**Coal Combustion Waste Impoundment  
Round 5 - Dam Assessment Report**

*Greene County Steam Plant (Site 013)*

*Fly Ash Dike*  
*Alabama Power Company*  
**Greene County, Alabama**

Dewberry & Davis, LLC  
Fairfax, Virginia

Figure 5.6.2-1. Main Spillway Outfall.

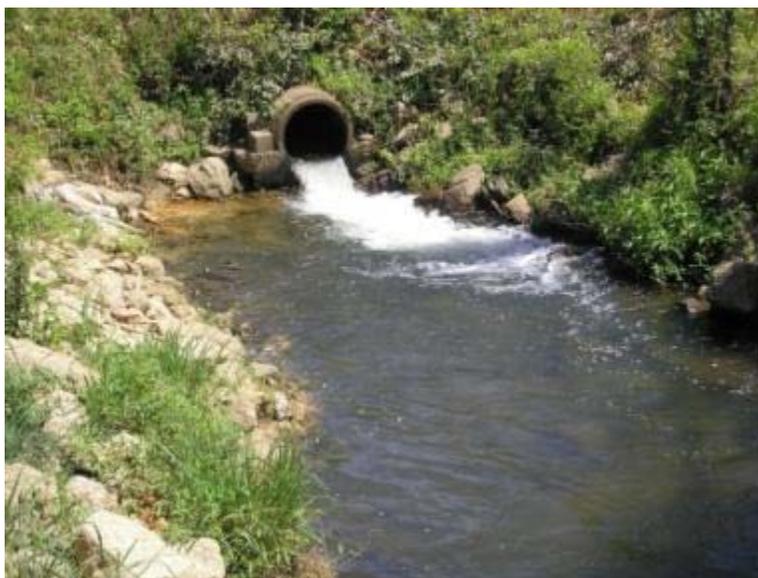
The outlet conduit appeared to be in good shape and operating normally with no sign of clogging and the water exiting the outlet was flowing clear. Figure 5.6.2-1 shows the water discharging from the main spillway tunnel outfall. Photographs 27 and 28, Appendix B provide additional views of the spillway outfall conduit and channel.

**Photo IN-13: Typical Condition of Downstream Face, NW Portion of North Dike**

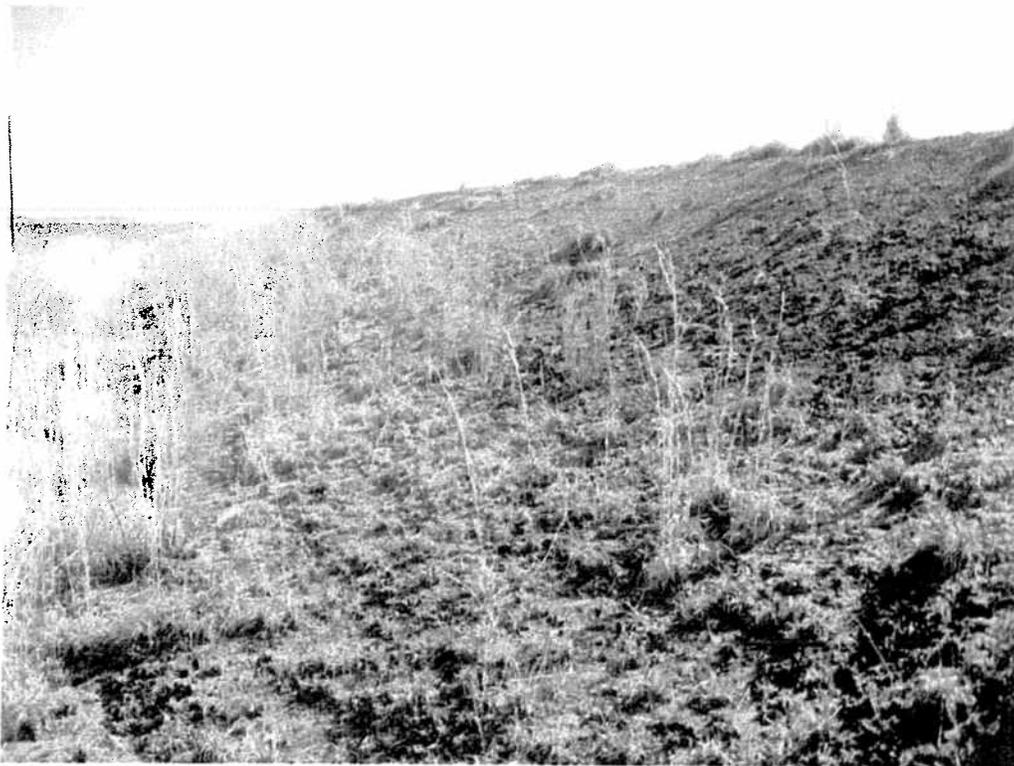
The north dike was inspected, beginning at the northwest corner of the pond and heading back toward the main plant facilities. One inspector walked the full length of the dike along the crest and one inspector walked the full length of the dike along the toe. It was noted that most of the downstream face of the northwestern portion of the north dike was not protected by vegetation, and numerous small rills (nothing of any major concern) were observed on the downstream face (see Photo IN-13). It is recommended that an attempt be made to establish a grass cover for this embankment. About 100 yards northeast of the northwest corner of the dike, several small seeps were observed along the downstream toe (see Photos IN-14 and IN-15). Water was not observed to be flowing from these locations, and dike material was not being transported. The dam height at this location appeared to be on the order of 10 feet, and the depth of the water on the upstream side appeared to be less than 5 feet.

**Photo IN-15: Small Seeps on Downstream Toe, North Dike**

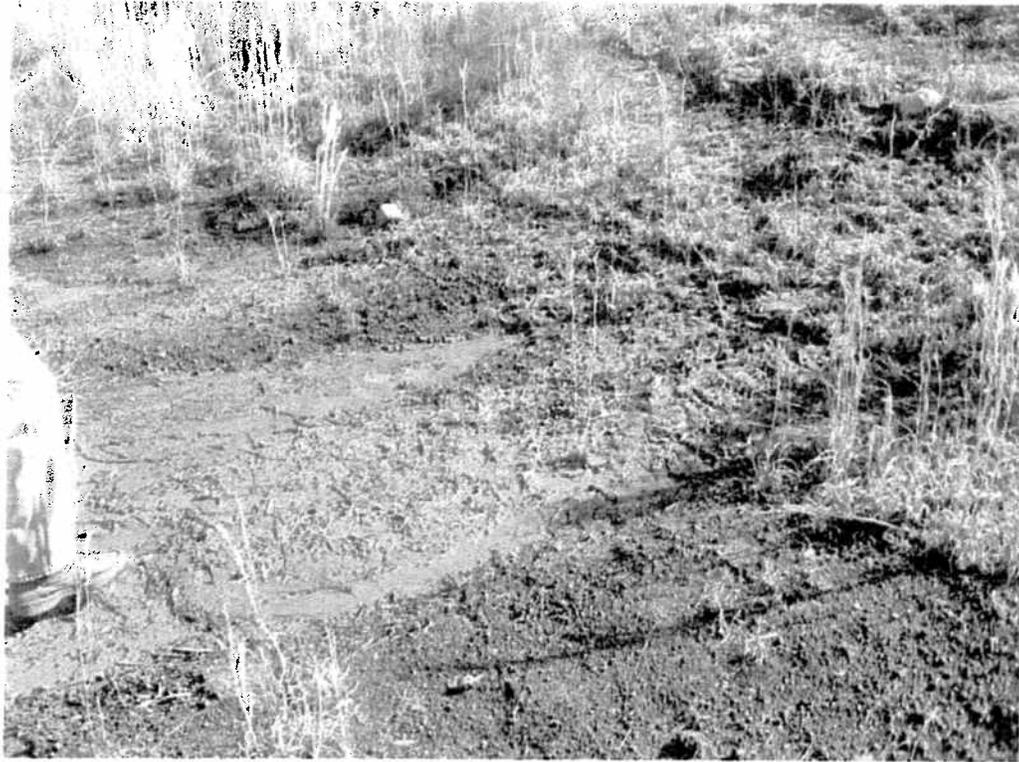
7	It is recommended that the plant staff, during their regular inspections, pay close attention to any wet areas or areas of known seepage.	All Embankments, but especially the West Dike and North Dike (see Photos 15 and 17)

**Photo IN-17: Recently Raised Portion of North Dike**

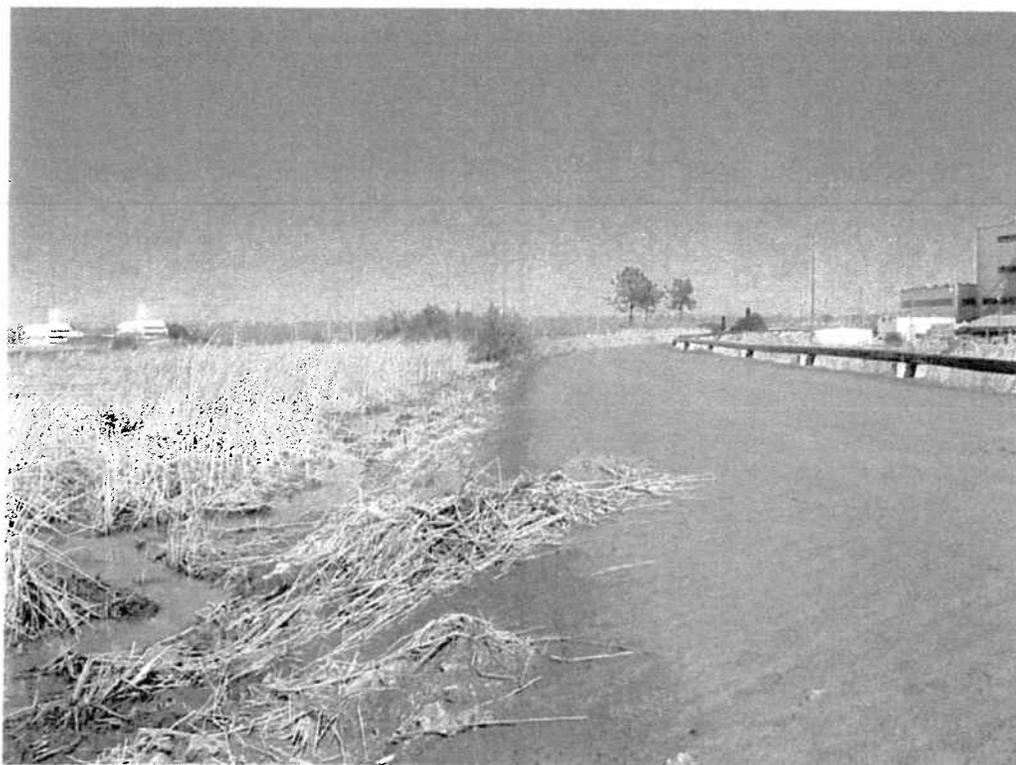
The remainder of the north dike was inspected, and no unusual conditions or concerns were noted. Closest to the main plant structures, the north dike is grassed and well-maintained (see Photo IN-16). A portion near the coal pile has recently been raised approximately 2 feet with on-site clay fill material (see Photo IN-17). The raising was performed to reduce the risk of overtopping at this location.
